**WRITTEN REPRESENTATION
ON BEHALF OF McDONALD'S RESTAURANTS LIMITED
PROPOSED HIGHWAY WORKS A38, DERBY**

ADL/RG/2680/05D

November 2019

Document: Written Representation
Project: Proposed Highway Works A38, Derby
Client: McDonald's Restaurants Ltd
ADL Reference: 2680

CUSTOMER TRACKS

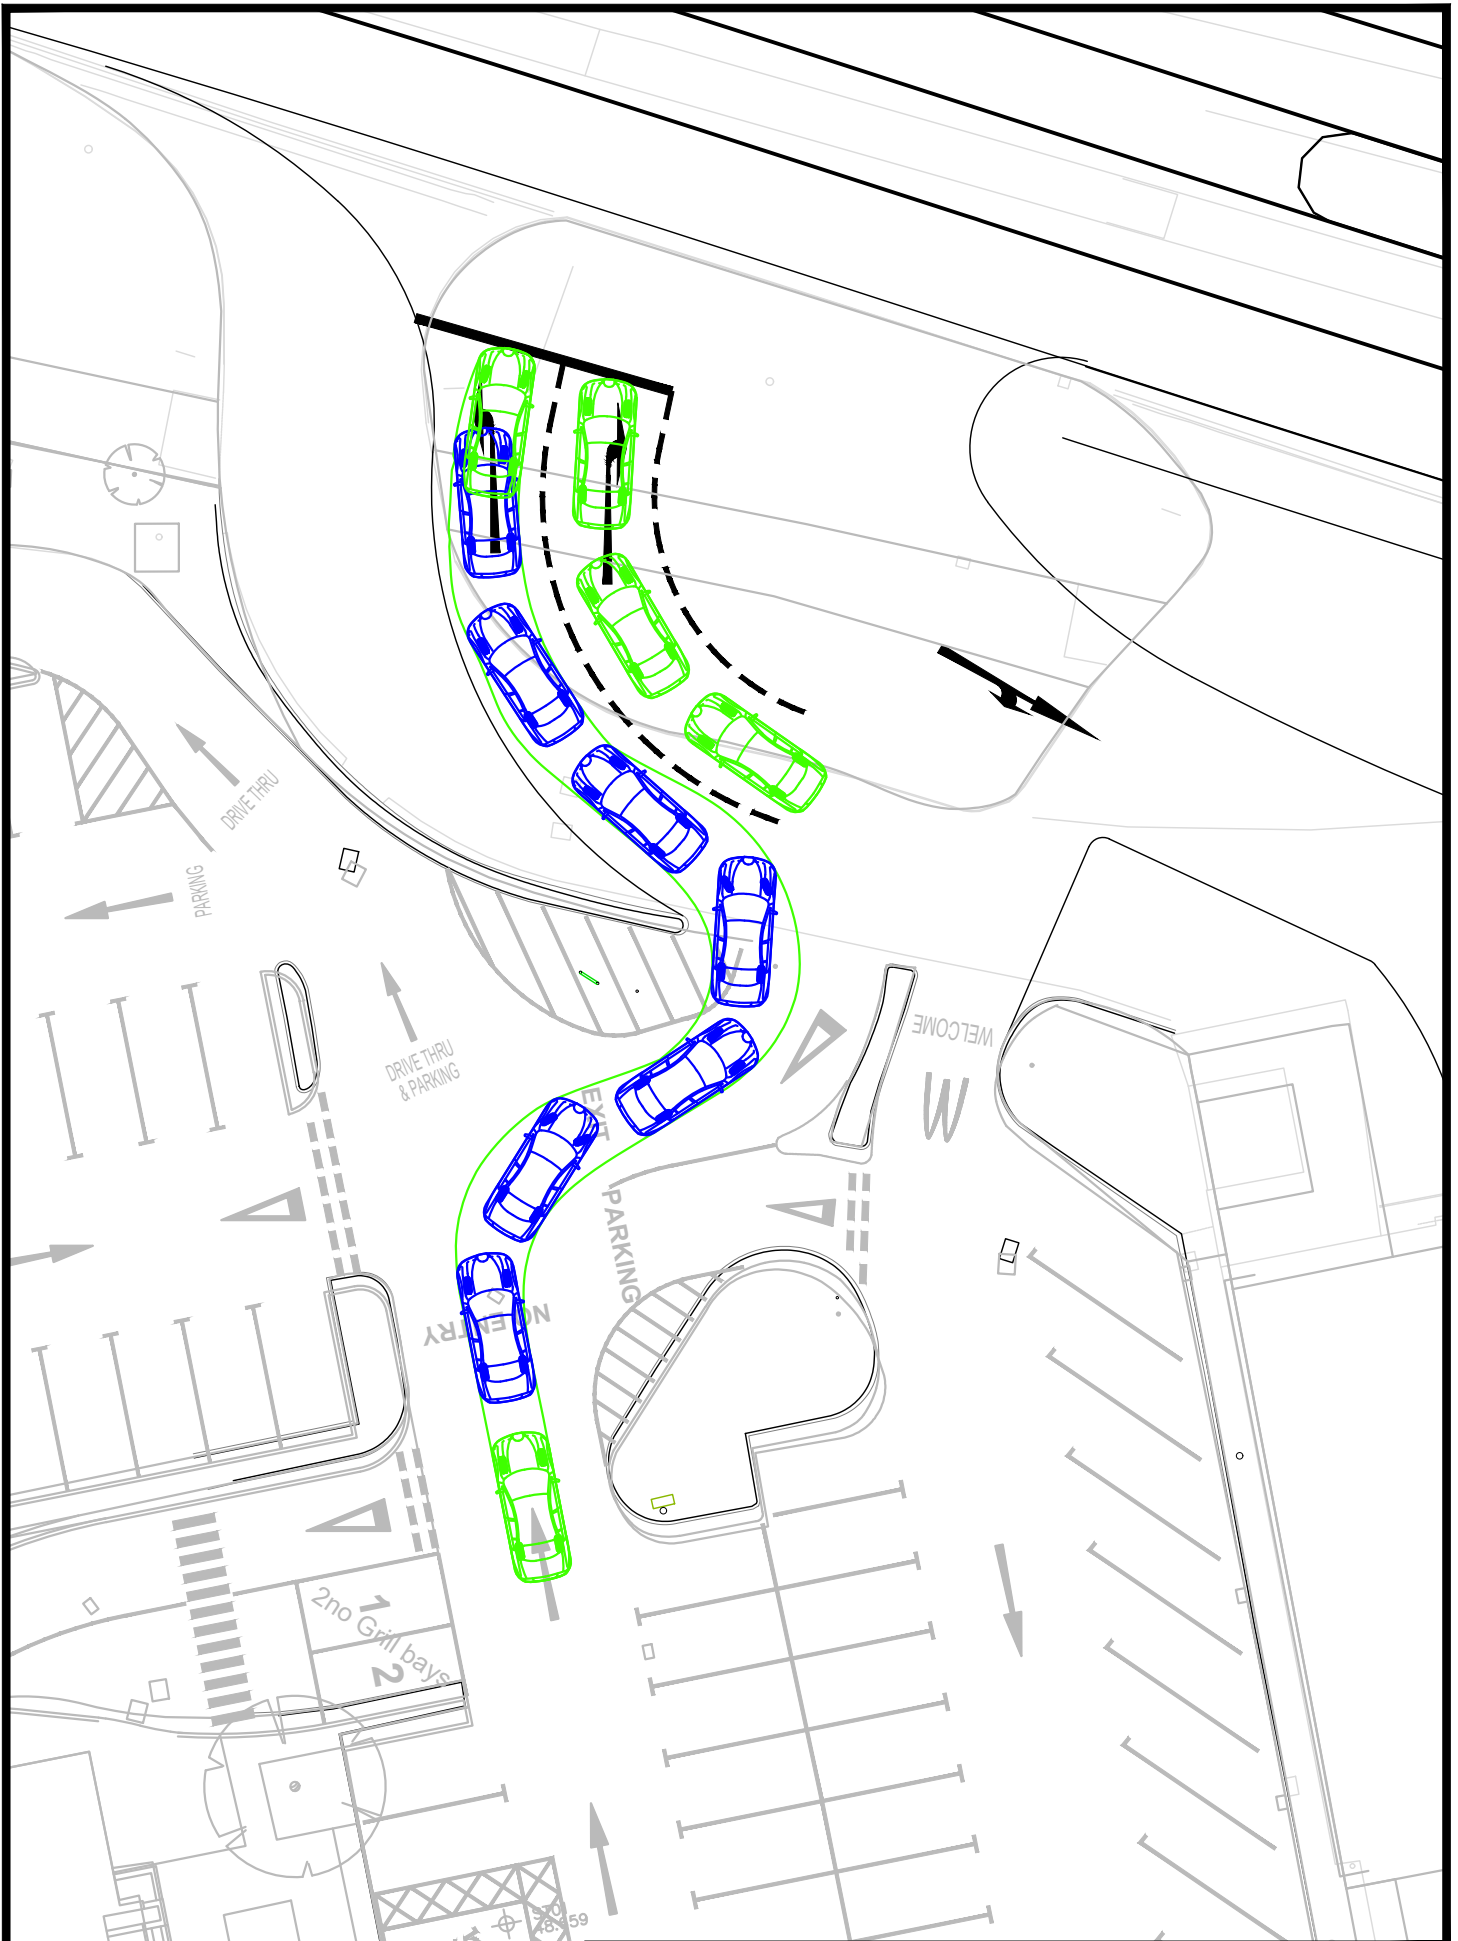
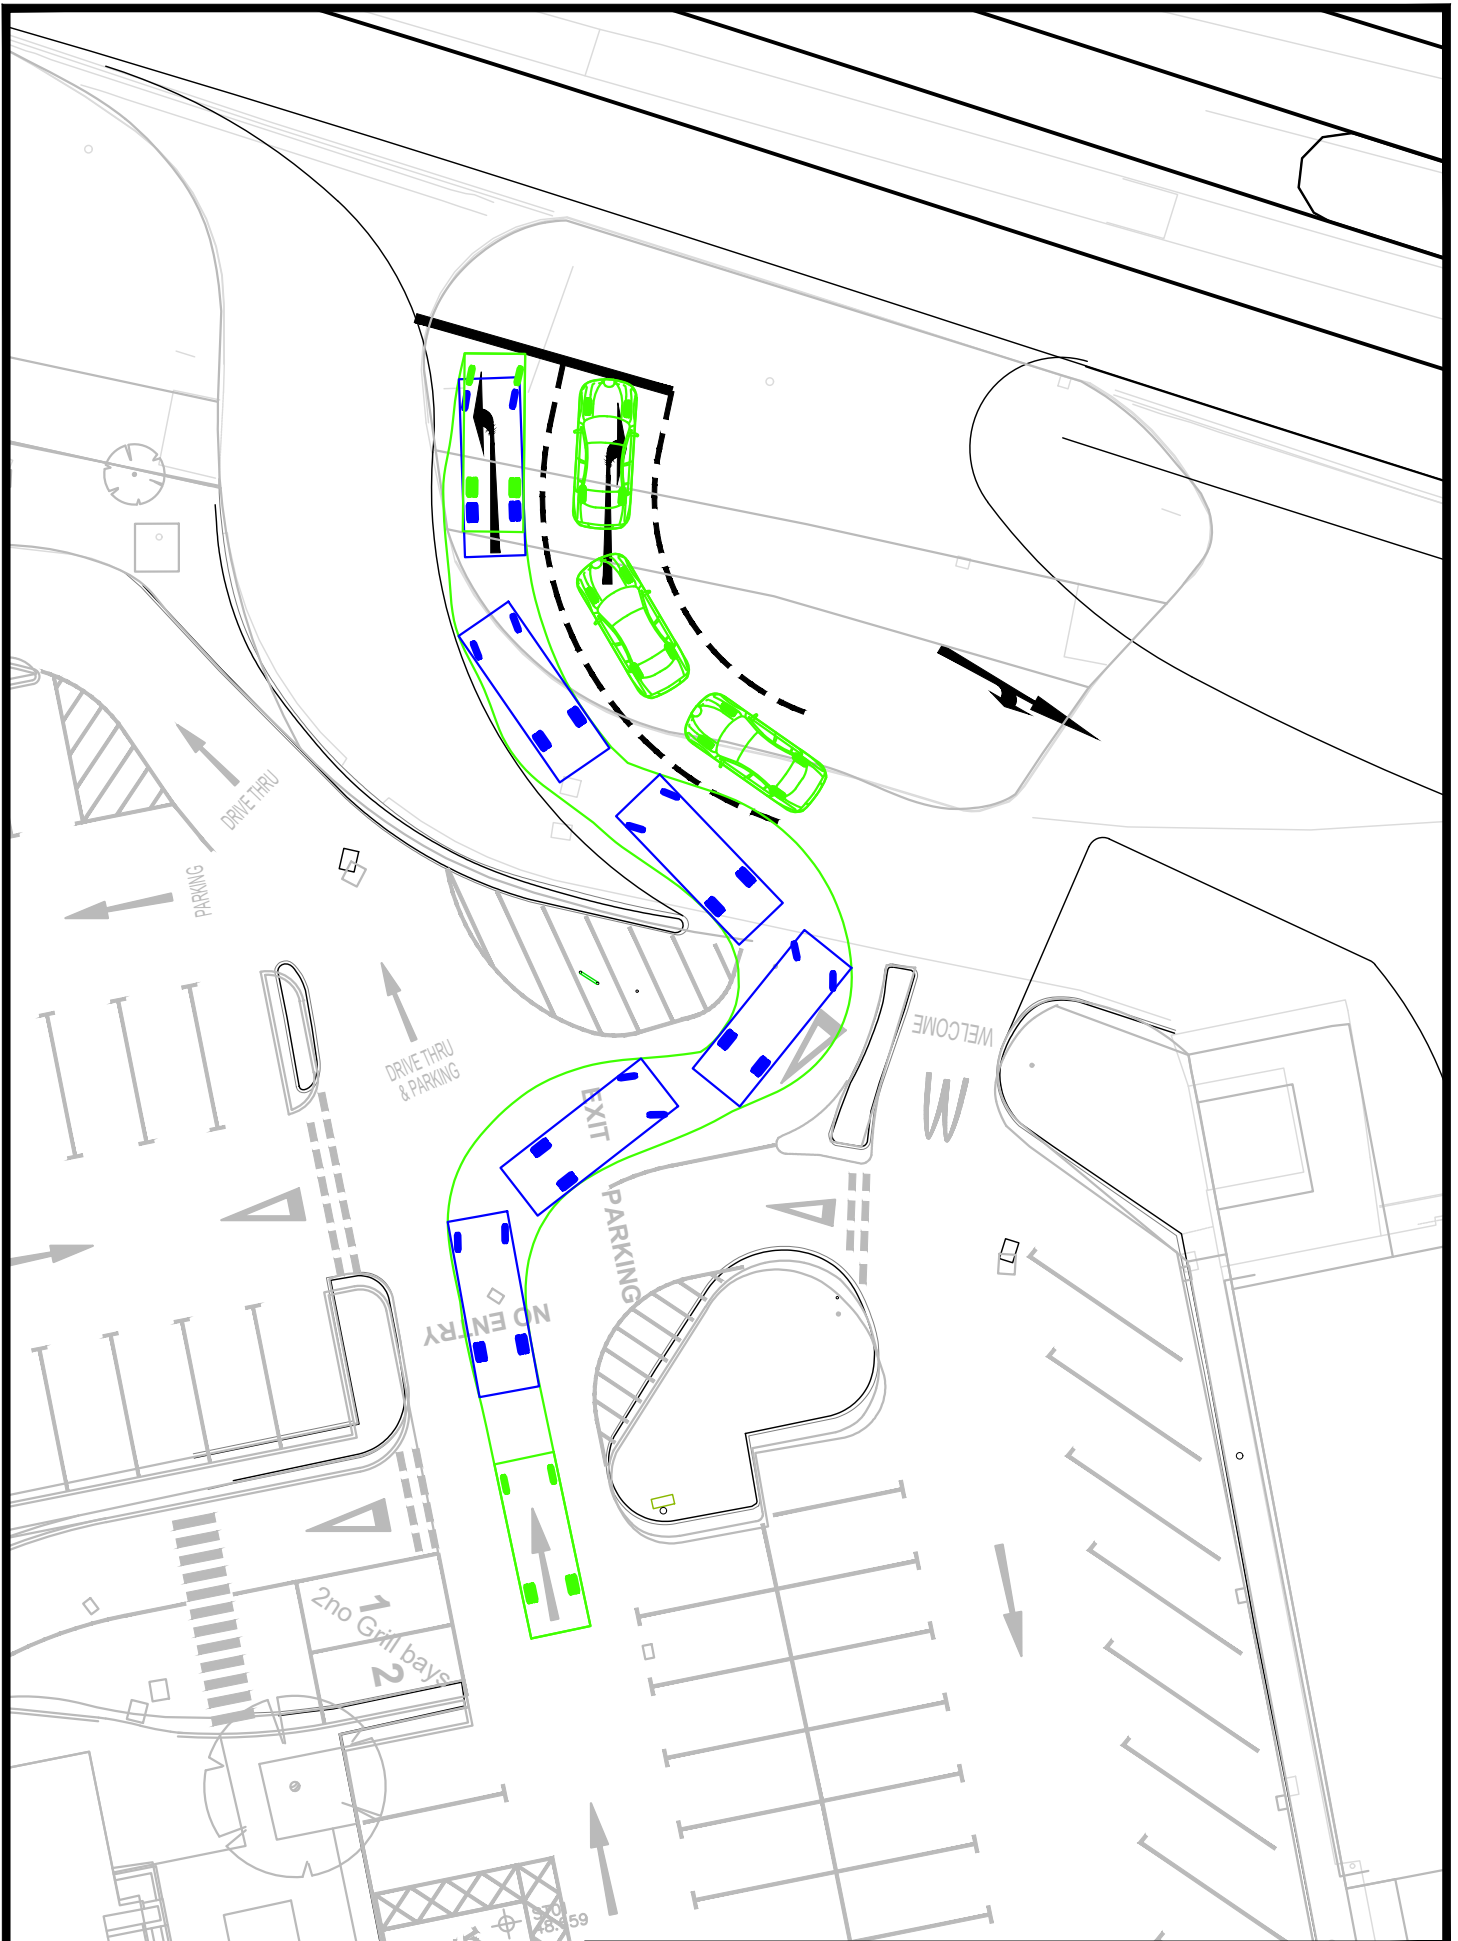
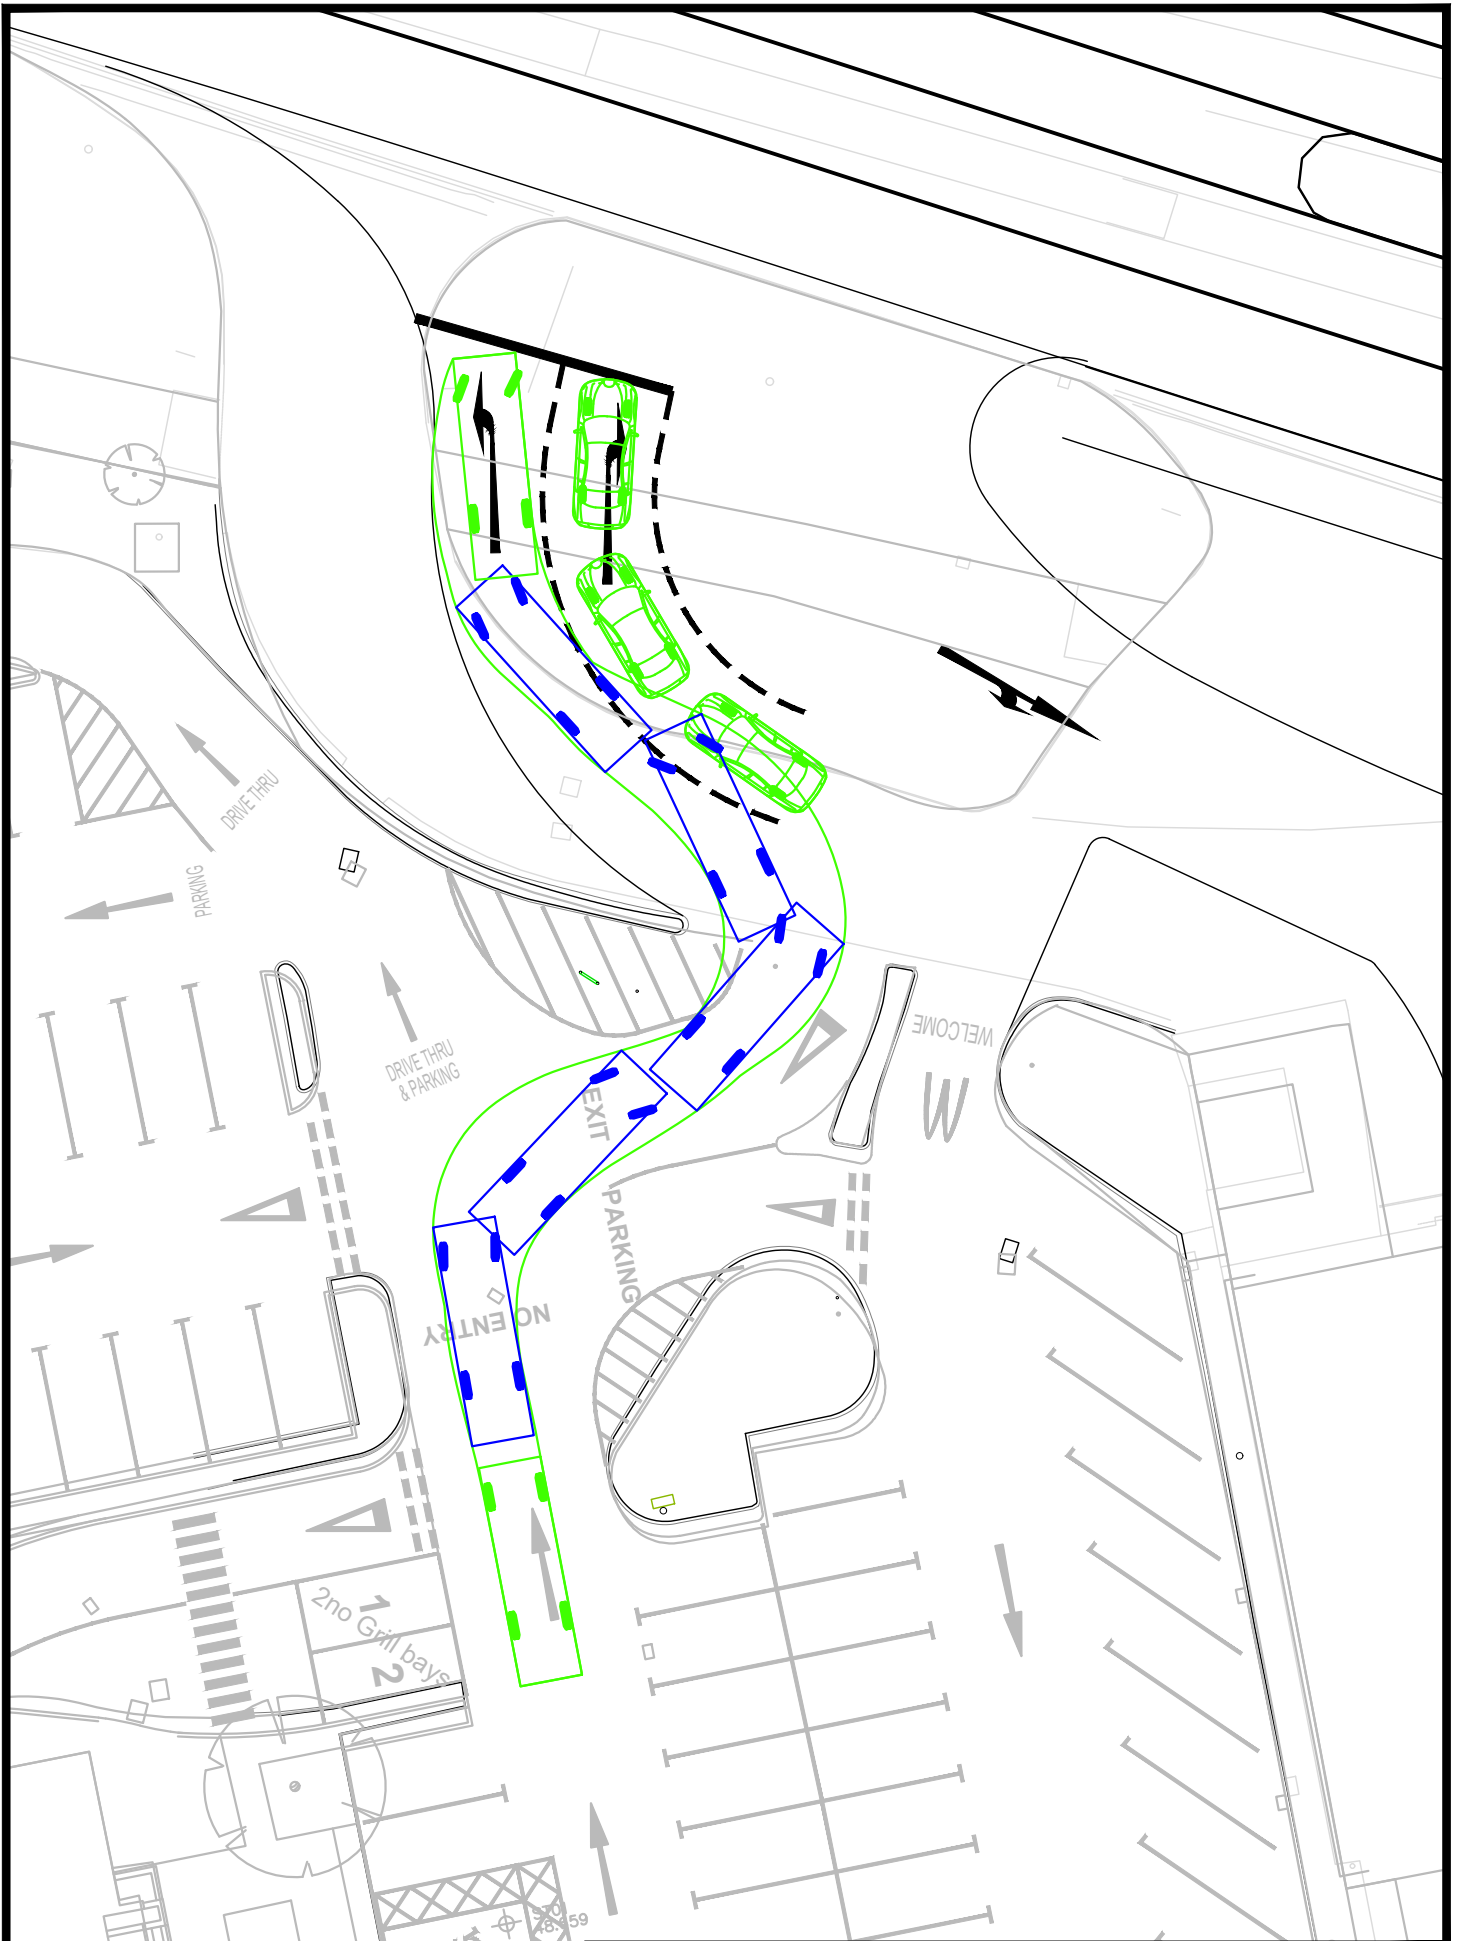
3.2.9 Swept paths of the proposed exit are shown at Appendices 5.1 – 5.3 for a large domestic car, medium size panel van and long wheelbase panel van leaving the site. These show that the exit manoeuvres needed are increasingly tight as vehicle size increases, and should a long wheelbase panel van seek to exit, then it would require both lanes to do so. Appendix 5.4 shows that a car seeking to turn right onto the A52 would block access to the left turn lane, unless the driver carefully considered their positioning within the carriageway. It is considered that the proposed signals do not provide sufficient space for daily operation and arrival/departure of customers.
